Planning, Land Use and Mobility Committee

CASE REPORT

Case Number: CPC-2022-6472

5353 Del Moreno Dr.

South Elevation of building

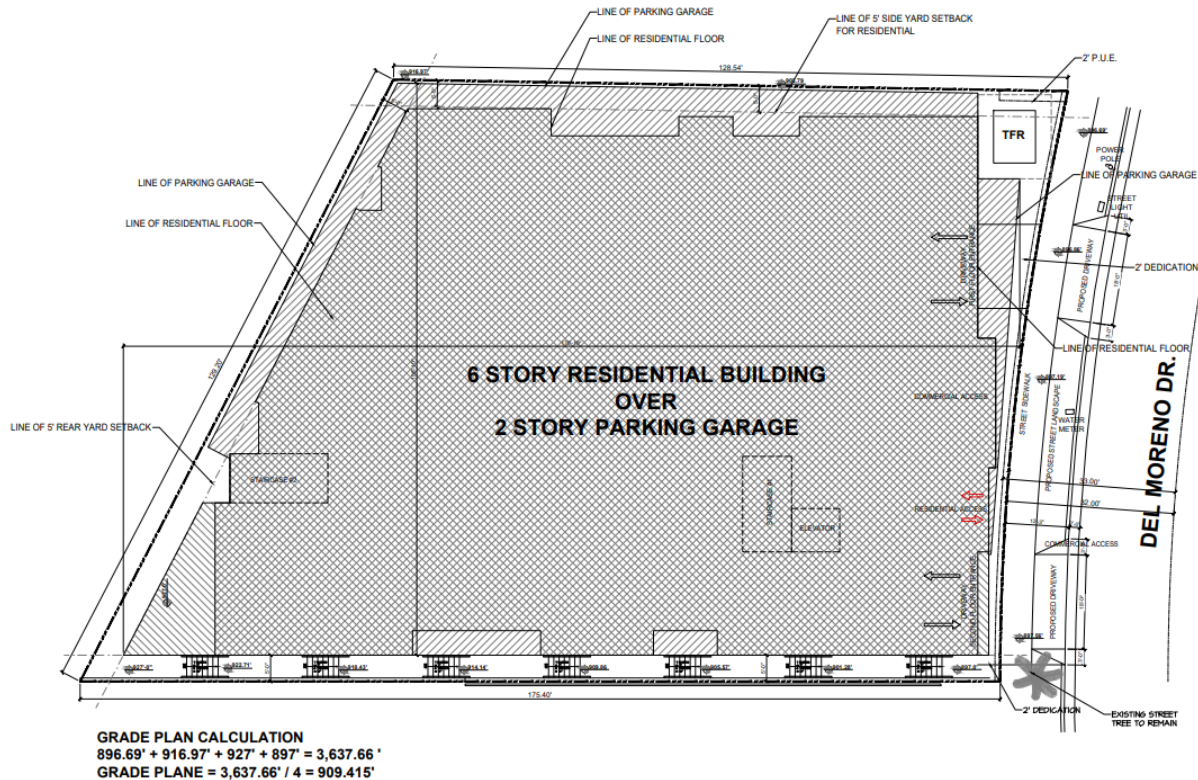
The Project calls for the removal of the existing residence and erecting an eight story mixed use building fronting Del Moreno Dr. The building will be 94 ft. tall from lowest point to the top of the parapet, and will encompass 90 percent of the building site, with 8 percent for paving and hardscape, and 2 percent for landscaping. The 1st floor of the building will be a lobby, retail space and parking; the 2nd floor will be a gym and additional parking; the 3rd floor would be very low income housing; and 4th through 8th floors would be for residential units. The building will have a 20 ft. setback in the rear, 11ft on the sides, and a 18 ft. setback in front—all requiring variances and exceptions from LA City building codes.
